Plan Commission

Agenda

Monday, July 27, 2020

SUBJECT: Staff recommendation and possible action regarding a site plan request for a new pet day care facility at 2140 American BL (Parcel WD-L179-8).

EROSION CONTROL
INLET PROTECTION
TYPE D-HR AND TYPE D-M

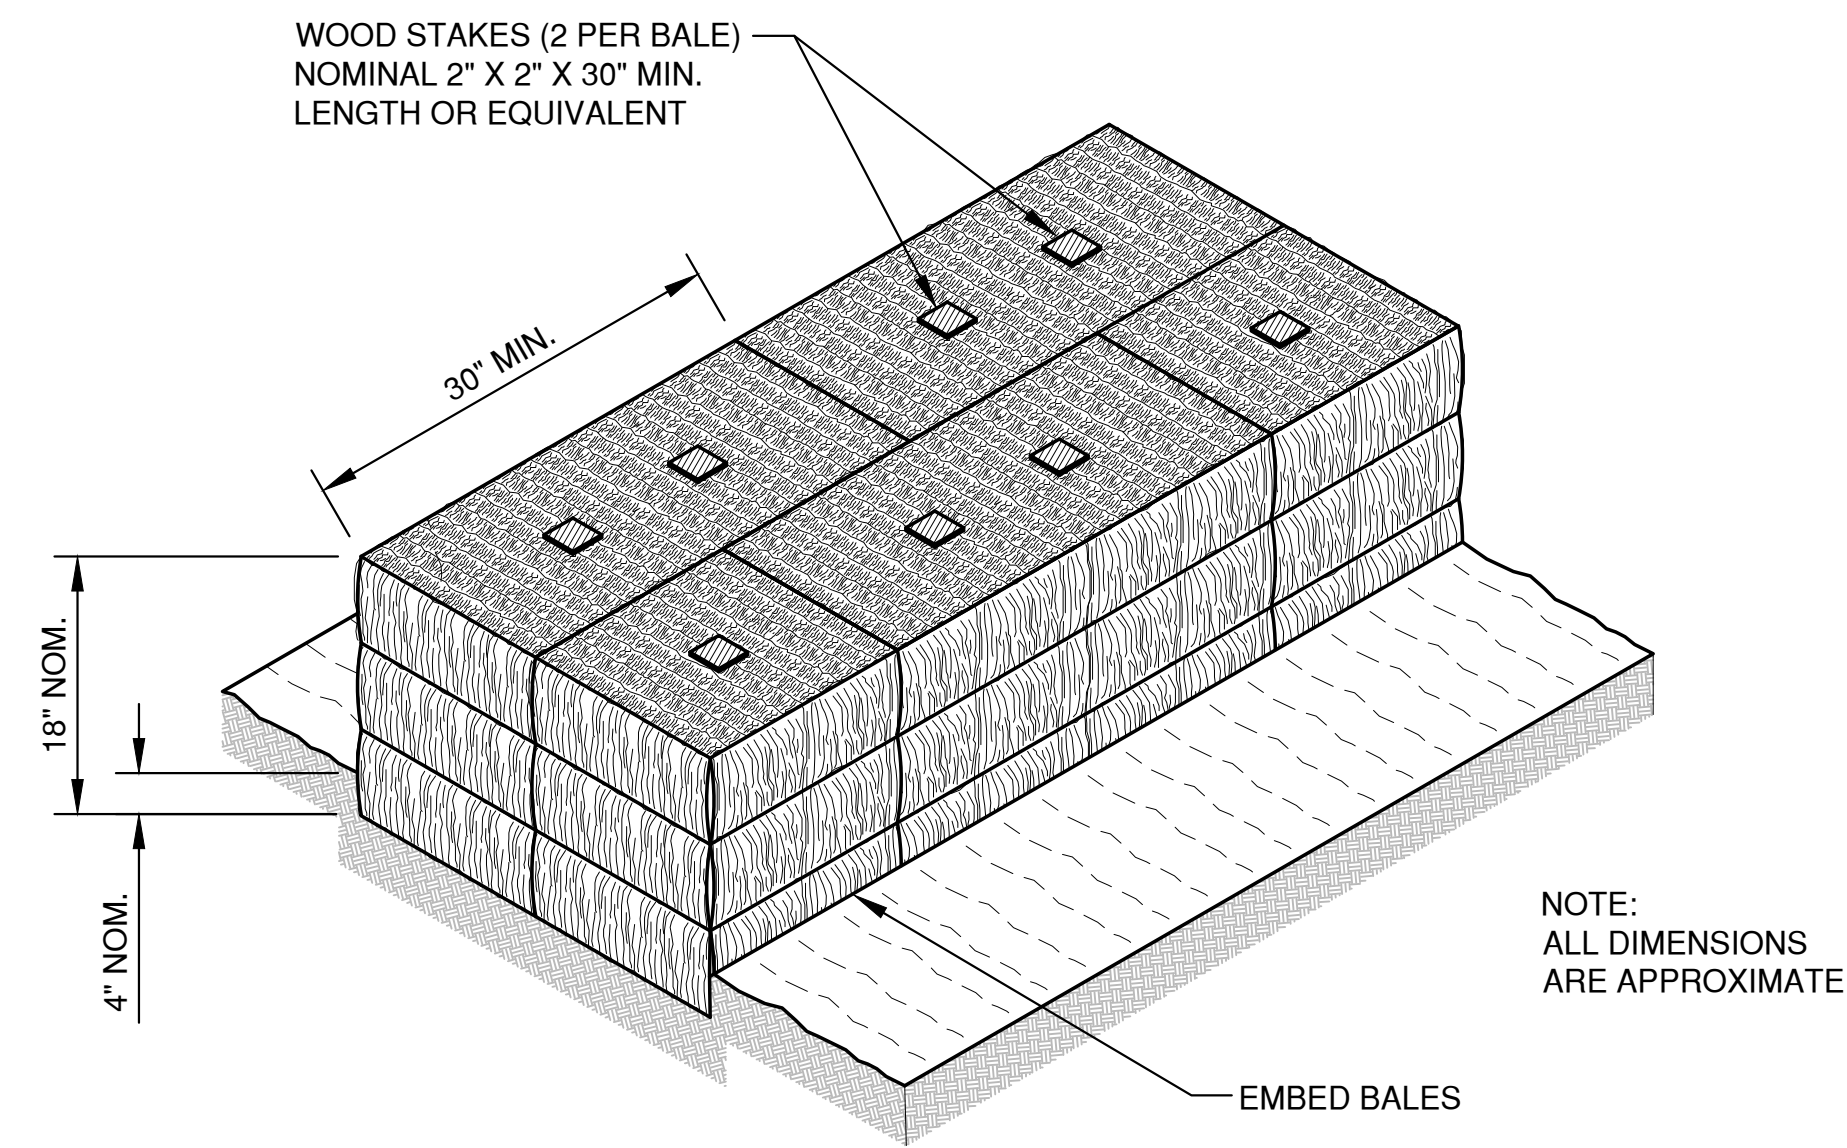
9. Sheet 5: Show stockpile location and protection around stockpiled materials.
10. Sheet 5: Inlet protection should be specified as TYPE D.
11. Sheet 5: Provide WisDNR soil loss sediment discharge calculations and corresponding map.

LANDSCAPING PLAN

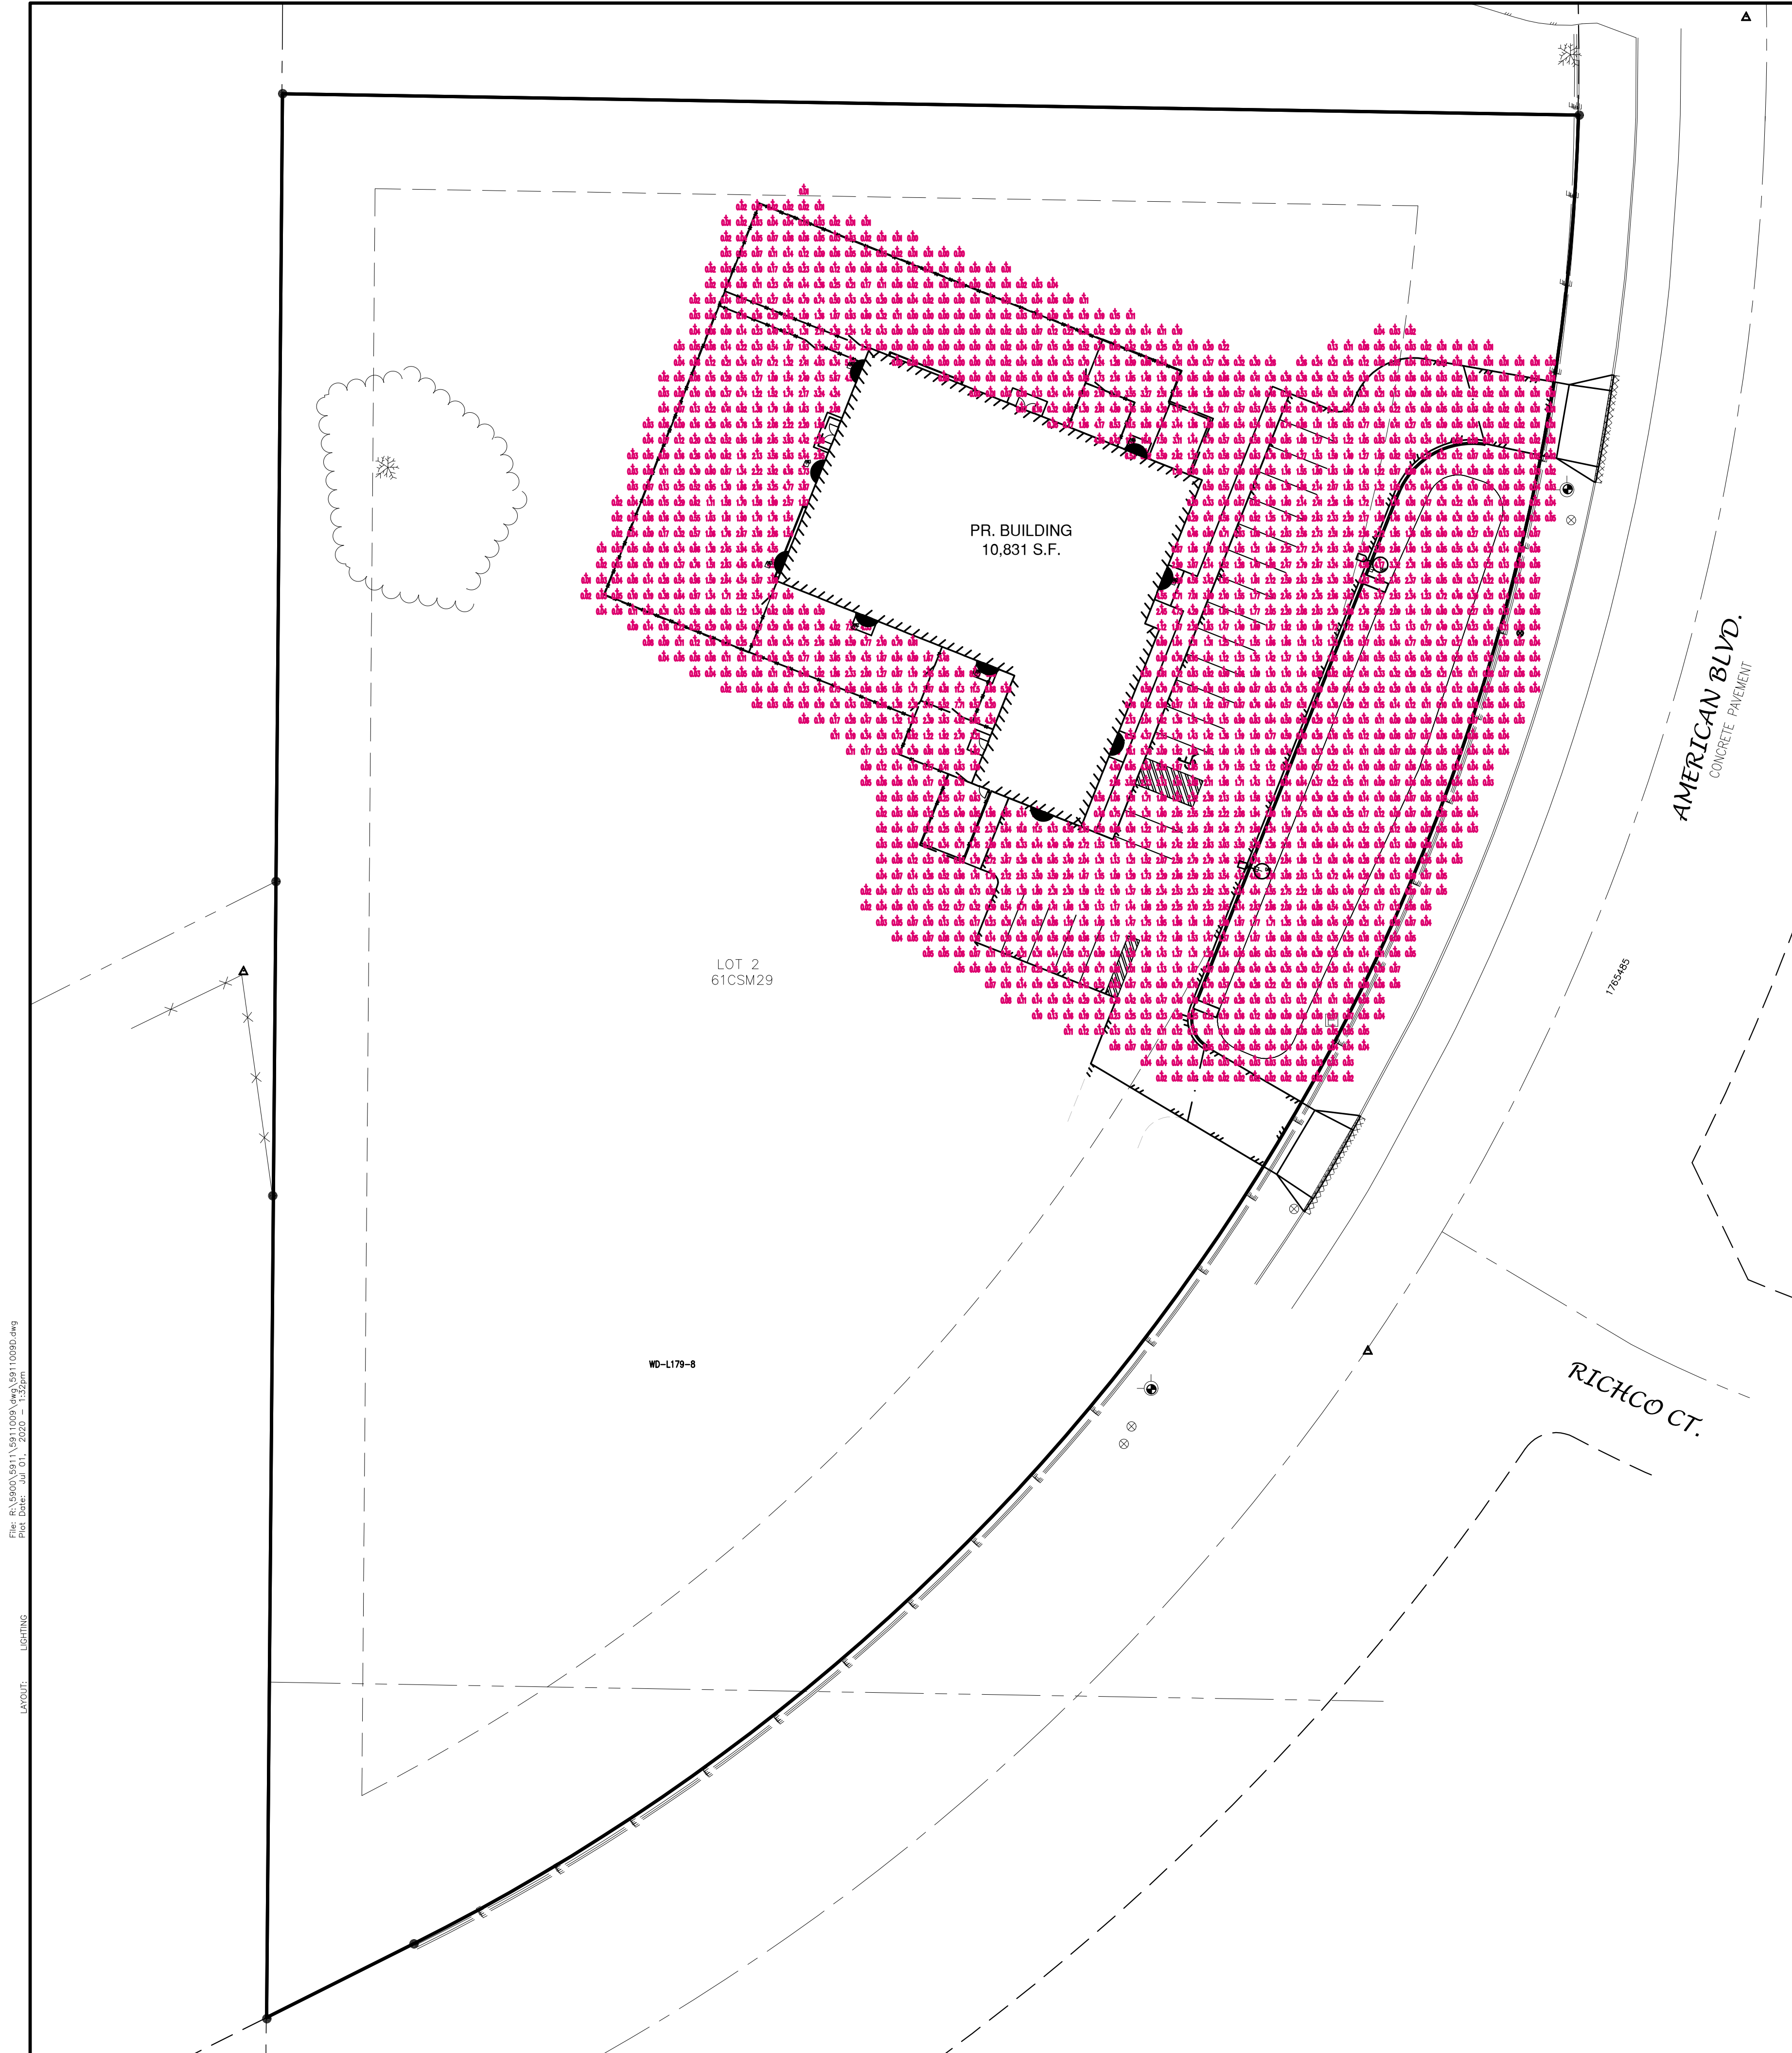
1. Sheet L2: The planting details are outdated and should be updated to reflect WDNR recommendations.

5. Sheet L2: Add landscaping to the west side of the dumpster, similar to what is on the south side.
6. Sheet A1.1: The site plan references two wall signs on the front (east) façade. Only one wall sign is permitted per business. For one business at this site the wall cannot be more than 117 square feet in size; if there are two businesses then the square footage is split based on linear frontage. If there are other sign types on the site plan, the type and location must be identified. A separate sign permit review/approval is required through the Inspection Department.
